REMARKS

Claims 36 and 39 are amended. Claims 40 is canceled. Claims 49-53 are added. Claims 36-39 and 41-53 are in the application for consideration.

ANNOTATED SHEET SHOWING CHANGES

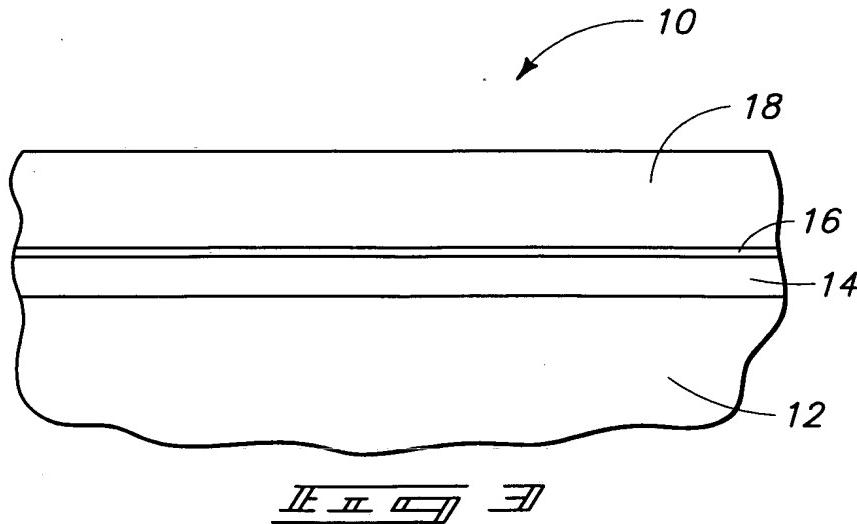
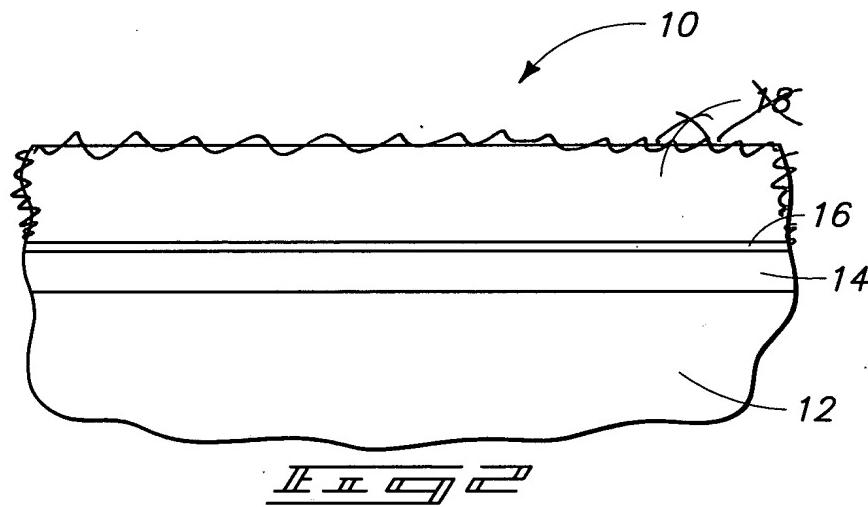
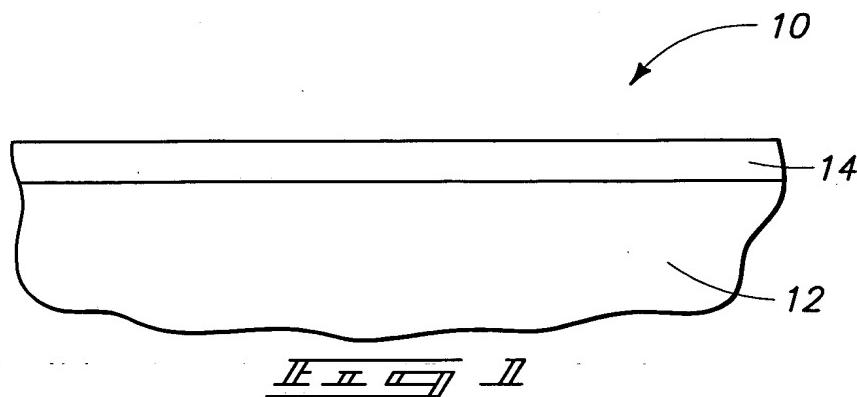
Substitute drawing sheets 1 and 3 are submitted herewith. Figs. 2 and 9 have been amended. Specifically, in Fig. 9, reference numeral 16 and the lead line extending therefrom have been deleted due to the removal of layer 16 and going from Fig. 8 to Fig. 9. Such is clearly supported in Applicant's application as-filed at, for example the last two paragraphs on page 4, and on page 9, lines 3-6.

Regarding Figure 2, it was noticed in reviewing the application in preparation of this response that Figures 2 and 3 as presented in the application as-filed are identical. It is clear from Applicant's application as-filed that Fig. 3 follows processing or is subsequent to the processing of Fig. 2 and that material 18 was intended to be shown as coming into existence in Fig. 3, not in Fig. 2. See, for example, Applicant's application as-filed at p.4, Ins.8, 9, and p.5, In.18 - p.6, In.18. Clearly, there is no reference to photoresist layer 18 in Fig. 2, with such only being introduced with respect to Fig. 3 processing. Accordingly, no new matter is added by fixing this minor oversight in Fig. 2. It is respectfully requested that the drawings as amended herein be entered.
